- 3. McCall Subdivision 2022 Replat  
KPB File 2022-166**

# McCall Subdivision, 2022 Replat Preliminary Plat

ITEM 3 - MCCALL SUBDIVISION 2022 REPLAT

STAFF REPORT

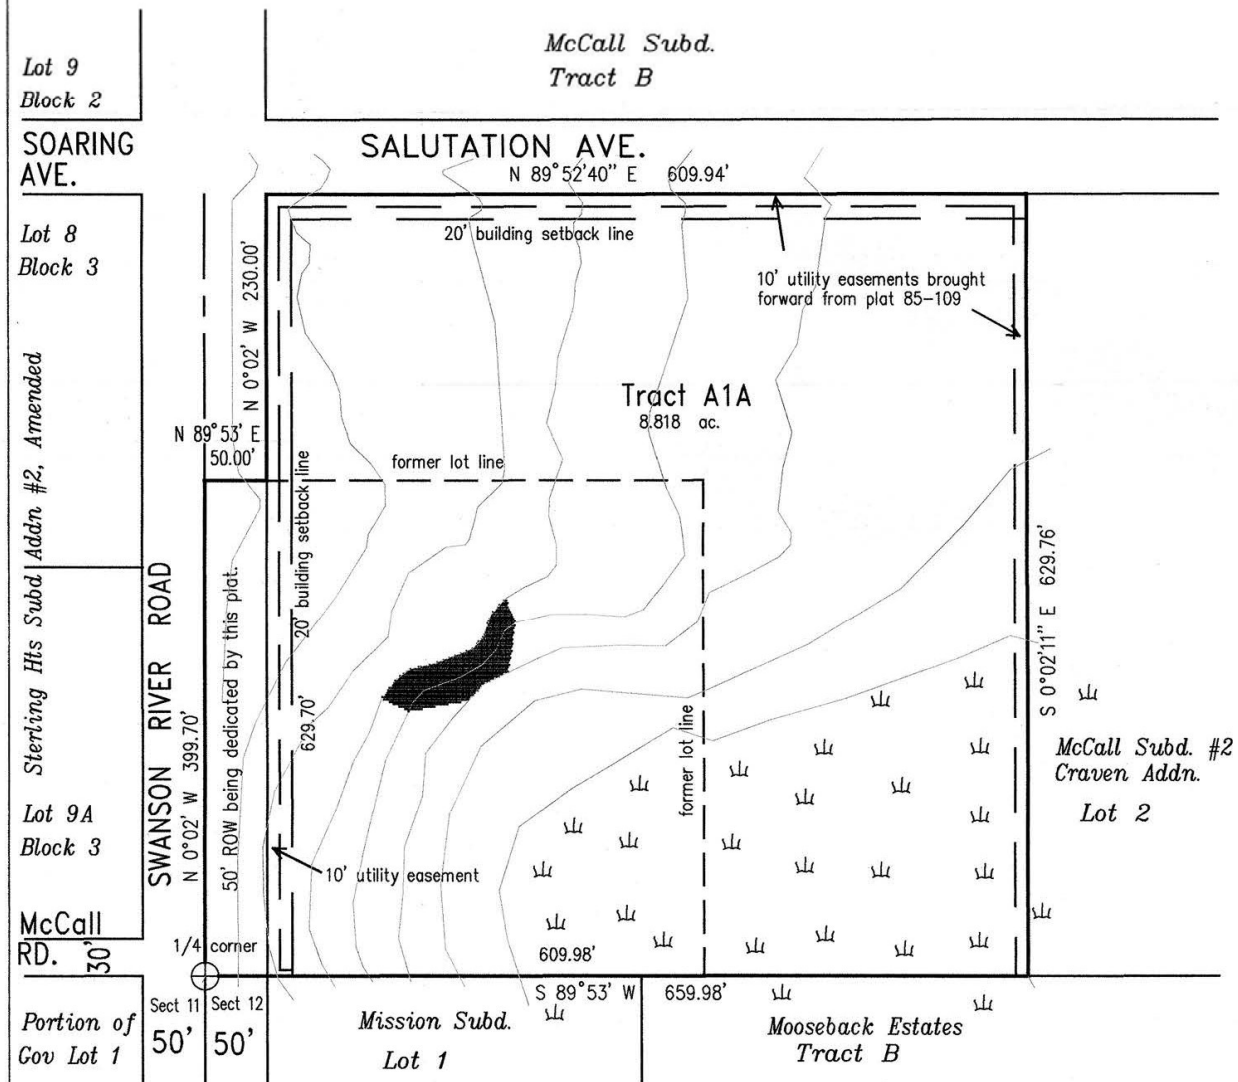
Section line easements are located within the Swanson River Road dedication. The section line easements do not need to be noted except in relation to the depiction of the Government Lot located to the southwest. That lot has not been platted and the Swanson River Road dedication does not appear to have occurred. The lot depiction should be revised and it should be noted that a section line easement is present.

**Site Investigation:** Low wet areas are present within the southeastern portion of the subdivision. **Staff recommends** the depiction of the low wet areas remain on the final plat and a wetlands determination note be added.

A small area of steep slopes is present within the deed parcel. The impact to development is minimal and existing structures are on the property. **Staff recommends** contours and steep slopes may be removed from the final plat.

**Utility Easements** McCall Subdivision, Plat KN 76-176, did not create any utility easements to carry over as the standard easements along dedicated rights-of-way were not required. A building setback was created. McCall Subdivision No. 2, Plat KN 85-109, granted 10 foot utility easements along Salutation Avenue, originally named Hi Avenue, and along the eastern property line. The plat has carried over the easements. **Staff recommends** the label for the easement be revised to state "granted by plat KN 85-109".

This plat will be granting 10 foot utility easements that increase to 20 feet within 5 feet of the side lot lines. These easements will be granted along Swanson River Road's existing dedication and the new dedication. **Staff recommends** the label include "granted by this plat".

- Add legend to drawing

**Staff recommendation:** The legal description will need to include more information regarding the deed parcel. As the legal description is long it may state "Deed parcel as described in warranty deed found in Book 188, Page 86, KRD.

**Staff recommendation:** Provide a width label for Salutation Avenue.

**Staff recommendation:** It appears that the portion of Government Lot 1 should be drawn to the section line with the section line easement labeled for that portion. Width label for Soaring Avenue should be added and update McCall Road width to 40 foot for the portion shown.

*Platting Staff Comments: Soils report is not required as lots are increasing in size and will be over 200,000 square feet. Add correct wastewater disposal notes.*

**Staff recommendation:** *The dedication of Swanson River Road will need to be accepted by State of Alaska DOT. Please work with DOT for correct authorized personnel and acquiring signature.*

**Staff recommendation:** *Place the following notes on the plat.*

- *"No access to state maintained rights-of-way permitted unless approved by the State of Alaska Department of Transportation."*
- *WASTEWATER DISPOSAL: Wastewater treatment and disposal systems must meet the regulatory requirements of the Alaska Department of Environmental Conservation.*
- *Restriction apply for water well locations per the terms and conditions within Book 286 Page 651, KRD.*
- *The borough will not enforce private covenants, easements, or deed restrictions per KPB 20.60.170.*
- *Any person developing the property is responsible for obtaining all required local, state, and federal permits, including a U.S. Army Corps of Engineers wetland determination if applicable.*

*Plat note 3 should include the original date with amendments being noted with their dates.*

*Plat note 4, replace "Kenai Records" with "Kenai Recording District" or "KRD".*
